Technical Bulletin

Model: Model K-P4	Date: 17	-Feb-05	No.: RG116001a
RTB Reissue			
The items in bold italics have been added.			
Subject: Controller Firmware Release History (System)	Prep	pared by: A. I	shiyama
From: 1st Tech. Support Sec. Service Support Dept.

This RTB has been issued to announce the firmware history for the System of the Model K-P4 (G116 model).

Important Note on the Bypass Feed Mechanism

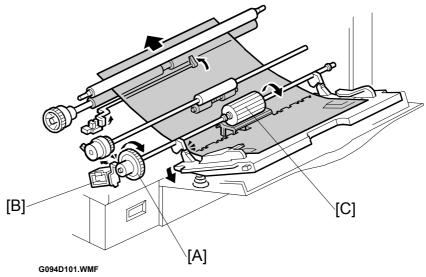
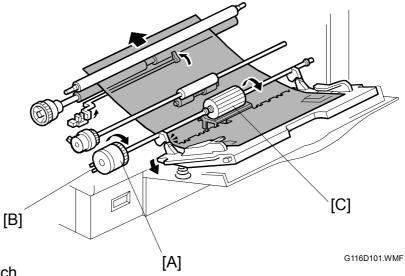
The paper feed mechanism for the bypass tray was *permanently changed* to a solenoid system. *This is to ensure high reliability of the paper feed mechanism.*

Solenoid System: Same as the C-P1/K-P3 system

Clutch System: Originally designed for the C-P2/K-P4

4. Attach the two Mylars to the **left and right** sides of the duplex unit, as shown below.

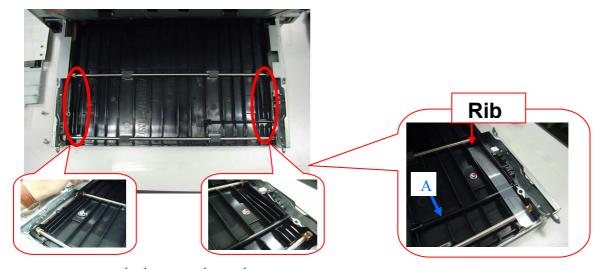
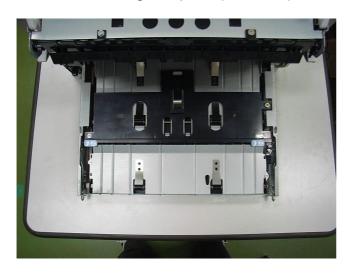
- Before you attach the Mylar, clean the attachment surface with alcohol.
- Make sure to align the Mylar against the rib as shown.
- Make sure the block does not touch the shaft [A].
